Access Compliance Report

Public Rights-of-Way

(Curb Ramps)

Intersection ID: 48714	Main Street: SARDIS_CREEK_LN	Cross Street: KILCULLEN_DR	Location: E
ADA ID: 8E8BDF7BB8DB	Ramp Type: Perpendicular Diagonal	Initial Pass/Fail: Fail	Overall Compliance: No
			Severity Score: 33.75

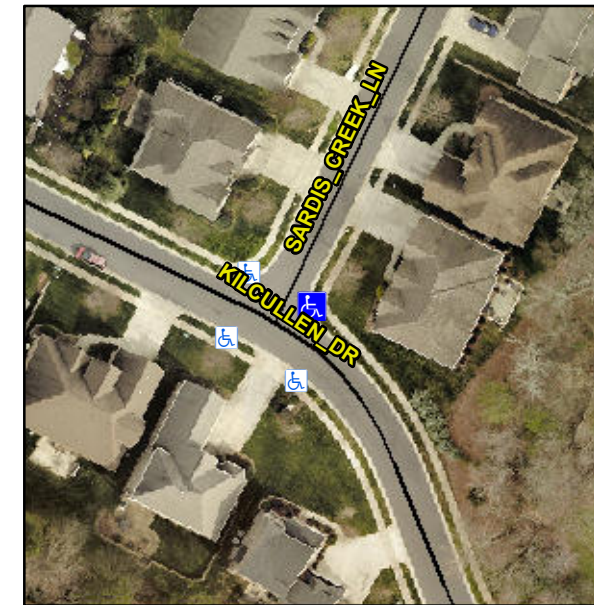
R304.5.1, R304.5.3

Remove & Replace Curb Ramp With Two New Directional Ramps or Equivalent.
